Docket No. 52-001

SUBJECT: FINAL REPORT TO DOCUMENT THE DISPOSITION OF THE IIRG COMMENTS
ON THE GE NUCLEAR ENERGY (GE) ADVANCED BOILING WATER REACTOR
(ABWR) INSPECTIONS, TESTS, ANALYSES, AND ACCEPTANCE CRITERIA
(ITAAC)

INDEPENDENT REVIEW GROUP COMMENTS REQUIRING DISPOSITION BY GE

Figure 10.4-1 Main Condenser Evacuation System

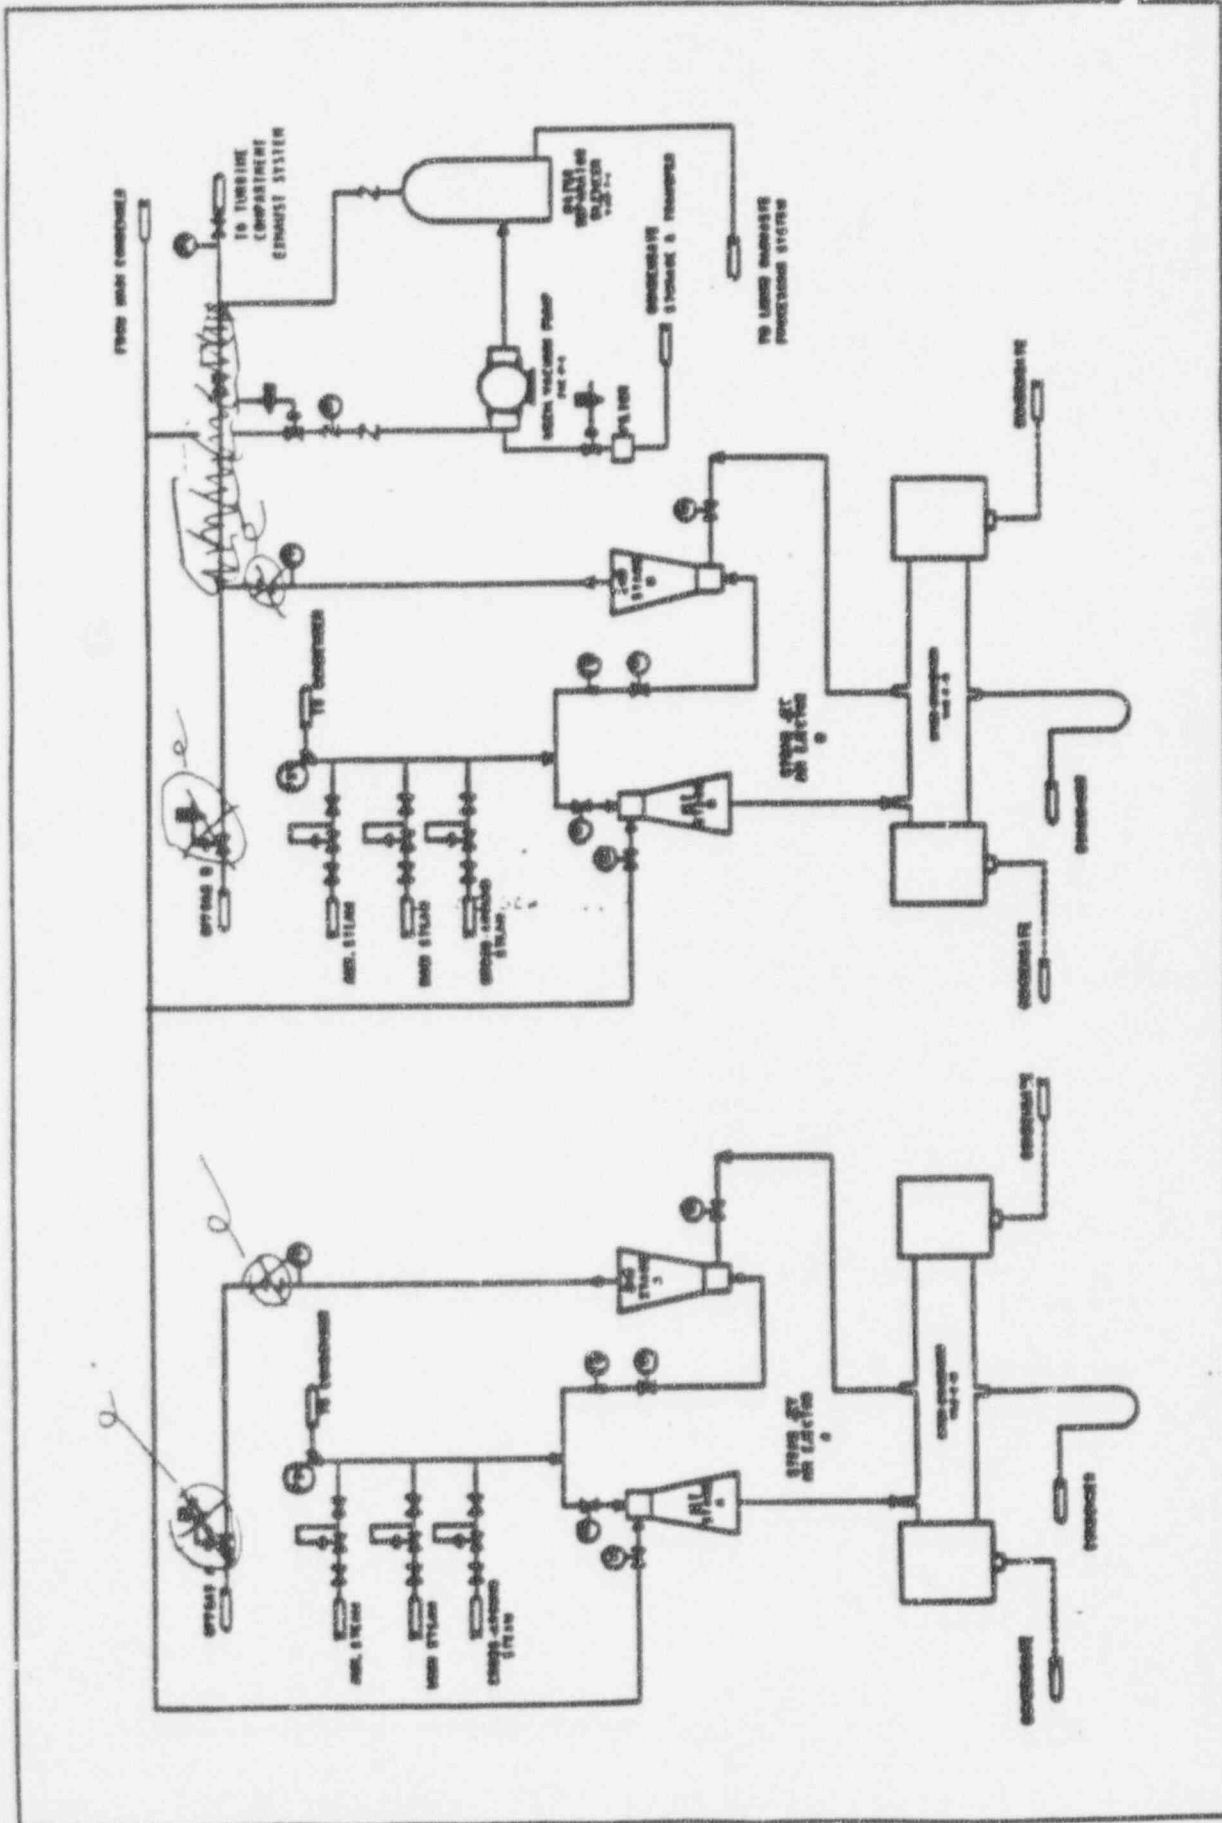
(Task Group:) Show SJAES discharge valves on ITAAC figure 2.10.2b as shown in SSAR figure 10.4-1. Also, explain why one of the SJAE discharge goes to "offgas-A" but not diverted to "turbine compartment exhaust system" in certain condition in SSAR figure 10.4-1 (see ITAAC figure 2.10.2b).

Figure 2.9.1b Radioactive Floor Drain Collection System

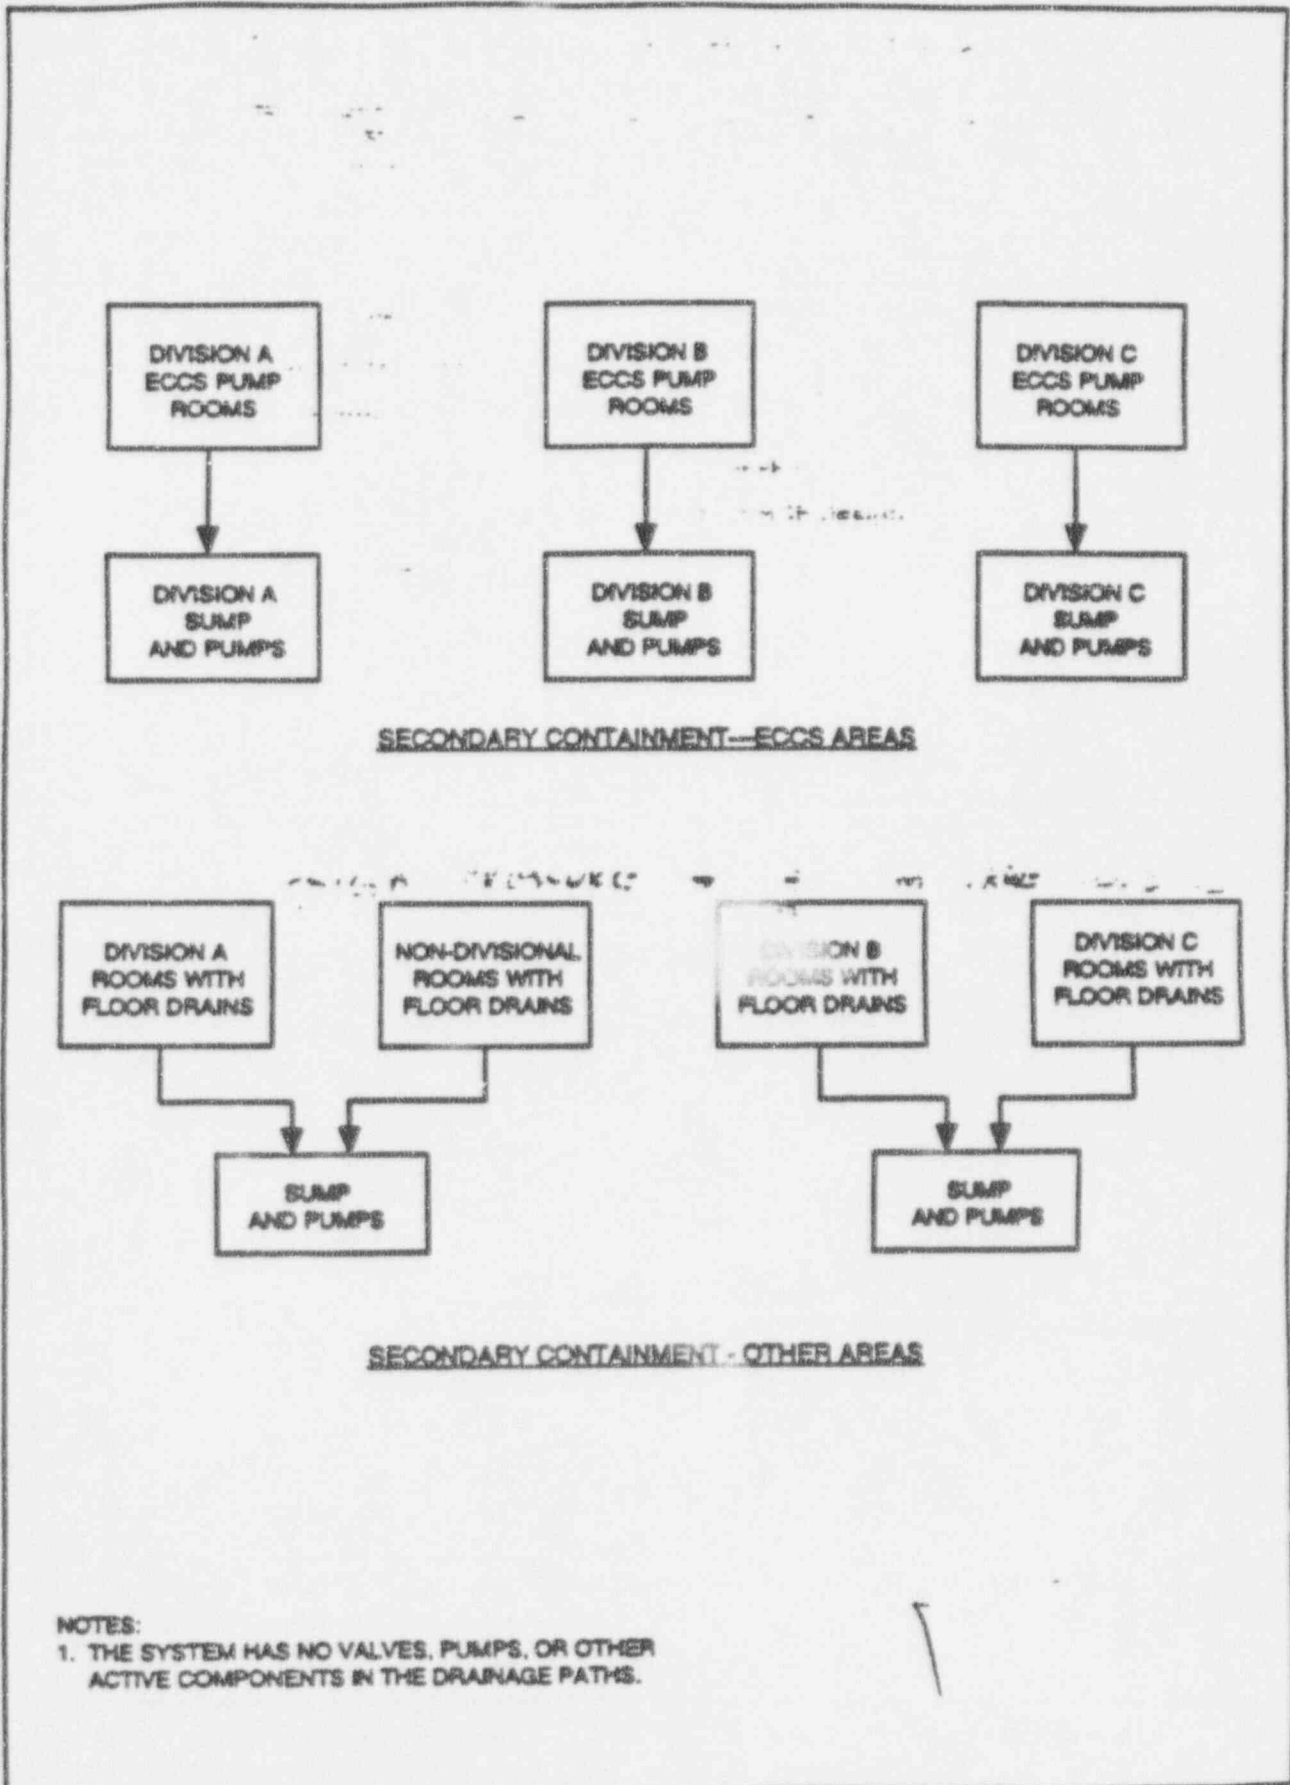
Figure 2.9.1.b should show ASME Code components, CIVs, active valves, and instrumentation.

Though the above are not explicitly shown in ITAAC Figure, they are addressed in ITAAC 2.4.3, "Leak Detection and Isolation System". See Item No. 11, Page 2.4.3-2, ITAAC Figure 2.4.3 and ITAAC Table 2.4.3. This is sufficient. The Tier 1 verification for this system is the isolation function on a LOCA signal. This isolation function is part of the Leak Detection and Isolation System function and so is verified there. The code class for these valves is provided in the 2.9.1 DD. Other aspects of the system are not Tier 1. The details of the drain system are to be provided by the COL applicant and therefore cannot be shown in any detail in Tier 1.

Figure 2.6.3 Suppression Pool Cleanup System

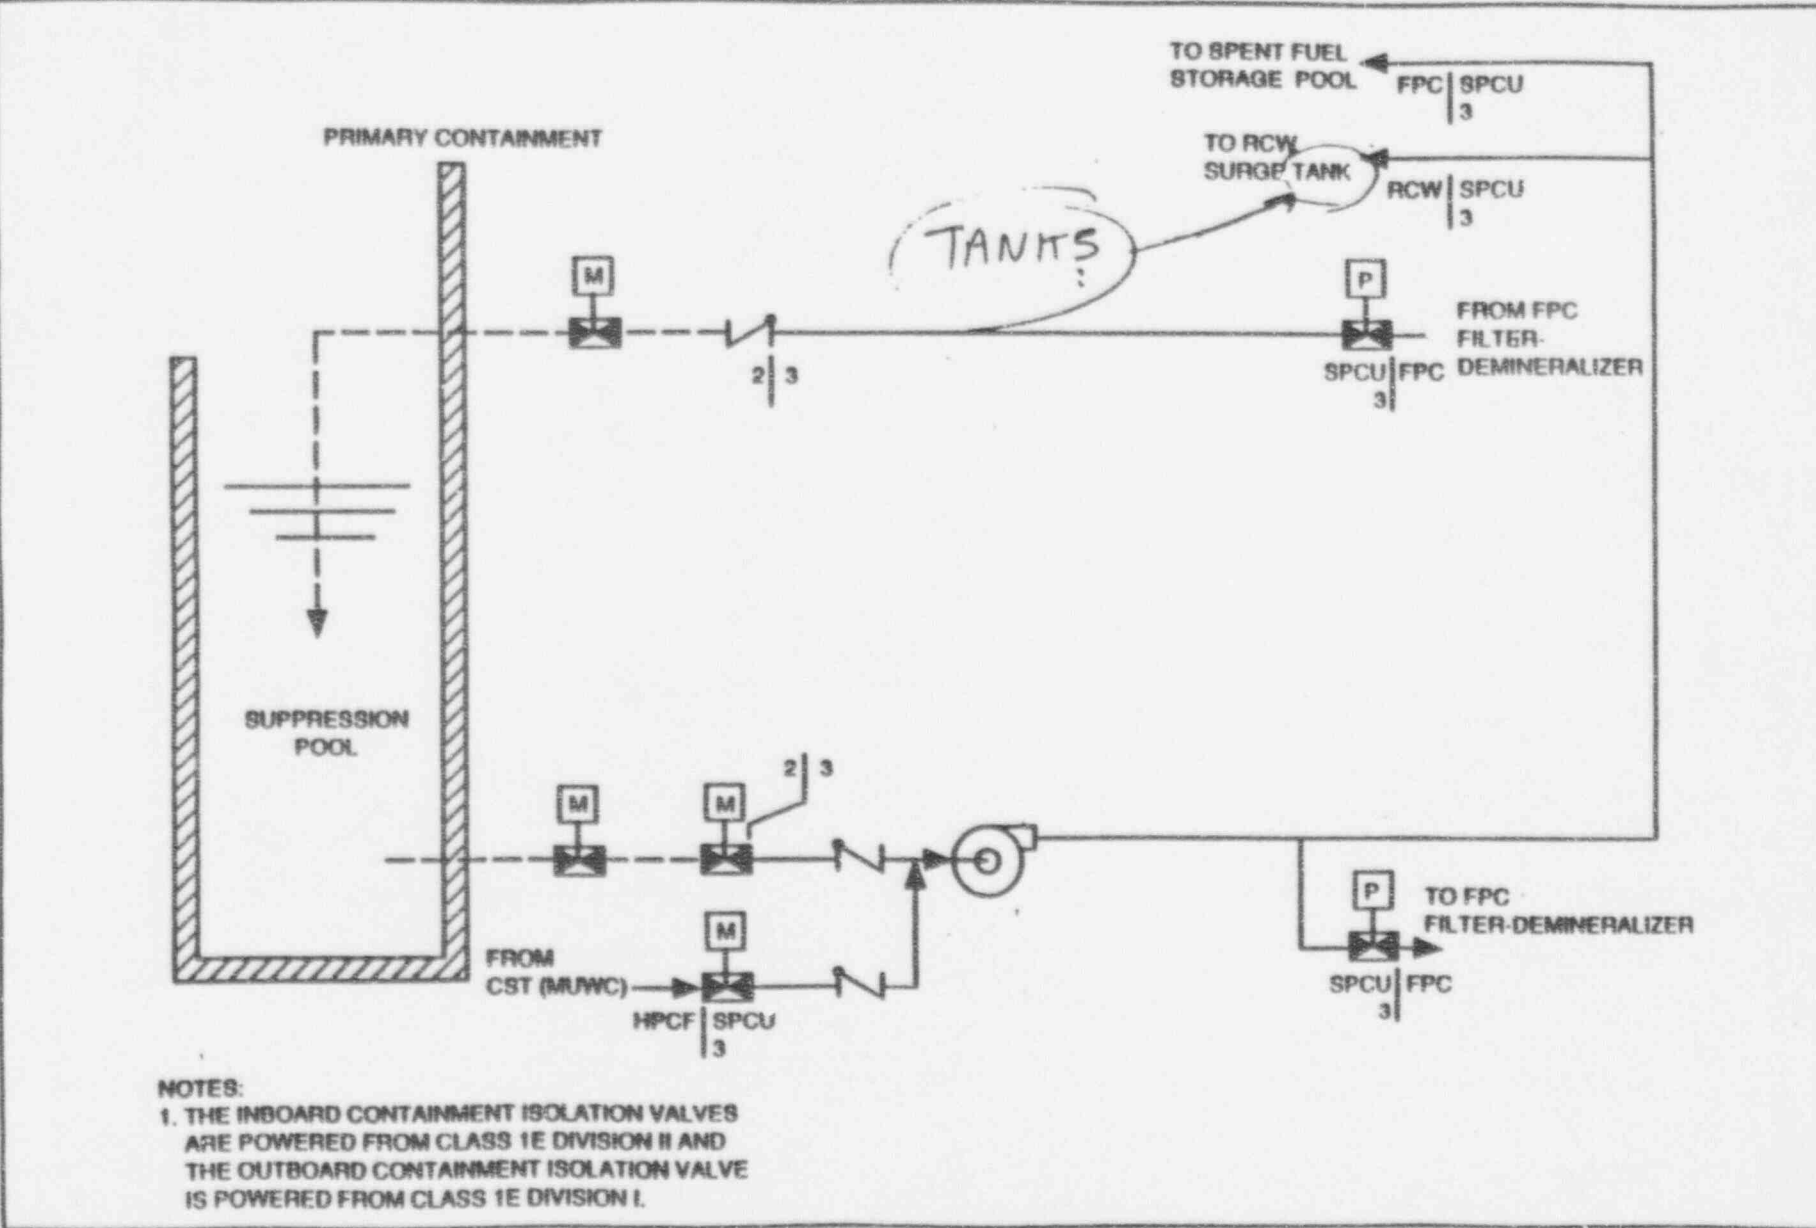
Figure 2.6.3: Change "SURGE TANK" to "SURGE TANKS".

Figure 2.6.3:
Add the parallel flow path with the pneumatic operator from the filter-demineralizer to the SPCU.

Figure 2.11.6a HVAC Emergency Cooling Water System (HECW-A)

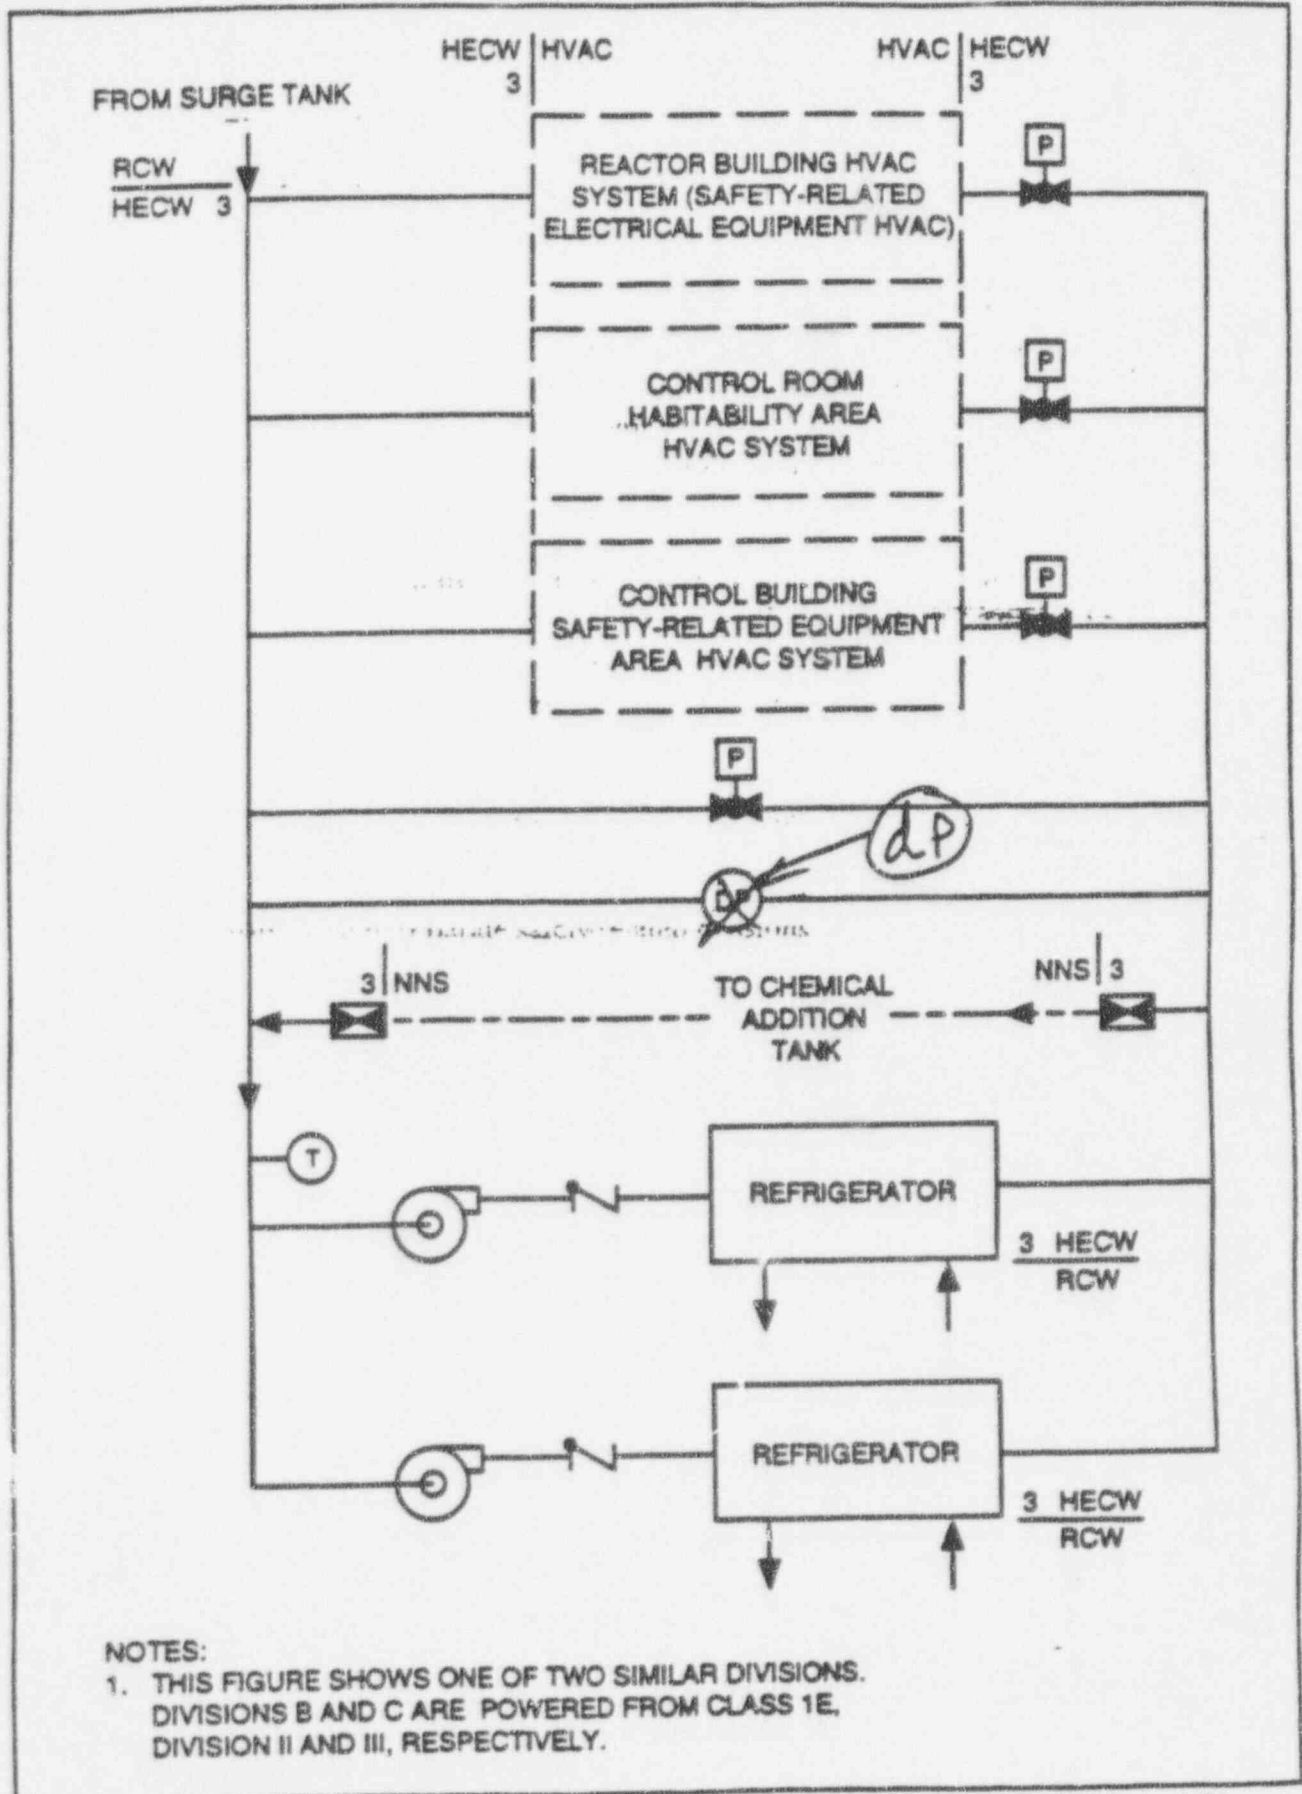
ITAAC 9, the Design Commitment Figures 2.11.3a and 2.11.3b should be 2.11.6a and 2.11.6b.

GE concurs and will include these changes in the revision of 25A5447.
